Proposal for Amendment 3 to UN Global Technical Regulation No. 9 (Pedestrian safety)

Submitted by the Working Party on Passive Safety*

The text reproduced below was adopted by the Working Party on Passive Safety (GRSP) at its seventy-fourth session (ECE/TRANS/WP.29/GRSP/74, para. 5). It is based on ECE/TRANS/WP.29/GRSP/2023/31 as amended by Annex II to the report. It is submitted to the World Forum for Harmonization of Vehicle Regulations (WP.29) and to the Administrative Committee (AC.3) for consideration at their June 2024 sessions.

"Figure 11
Determination of the Detection Test Area (see paragraph 3.19): examples

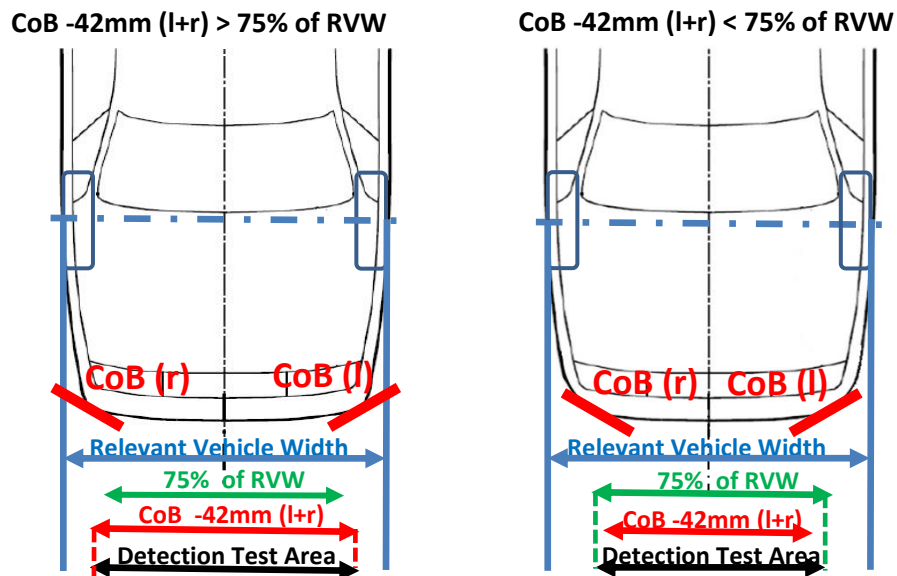
Insert new Figure 11, to read:

Figures 11 to 30 (former), renumber as Figures 12 to 31.
